## **TECHNICAL BULLETIN**

### **EQUIPMENT MAINTENANCE – PREVENTATIVE ACTION REQUIRED**

**SUBJECT:** PEELLE 250723 PINION GEAR

**EQUIPMENT:** PEELLE CAR DOOR OPERATORS (PART NUMBERS: 2518, 2517, 2548, 2547, 2528, 2527 AND 2549)

**250723 PINION GEAR**

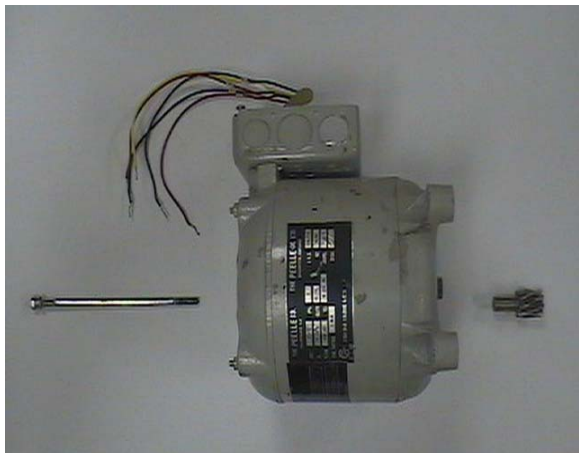
**DESCRIPTION:** PEELLE HAS DISCOVERED THAT THE MATERIAL USED FOR THE 250723 PINION GEAR ON THE ABOVE LIST OF CAR DOOR OPERATORS WAS NOT MANUFACTURED TO PEELLE'S HARDNESS SPECIFICATION. THIS COULD RESULT IN PREMATURE PINION WEAR. THIS APPLIES TO JOBS SHIPPED BETWEEN JANUARY 1<sup>ST</sup> 2002 AND OCTOBER 30<sup>TH</sup> 2002.

JOBS SHIPPED AFTER NOVEMBER 1<sup>ST</sup> 2002 HAVE BEEN CORRECTED.

**ACTION:** CONTACT PEELLE FOR A FREE REPLACEMENT 250723 PINION GEAR. FOR USA – CONTACT 1-800-645-1056 EXT. 11 LAURA NEUMANN. FOR CANADA AND INTERNATIONAL – CONTACT 905-846-4545 EXT. 220 LEN HOUWEN. TO REPLACE 250723 PINION GEAR:

1. TURN OFF POWER.
2. UNBOLT GATE MOTOR.
3. REMOVE CAP AT BACK OF MOTOR.
4. UNSCREW PINION BOLT EXCEPT FOR THREE THREADS.
5. HAMMER PINION BOLT HEAD TO LOOSEN PINION.
6. EXCHANGE PINION AND REASSEMBLE.
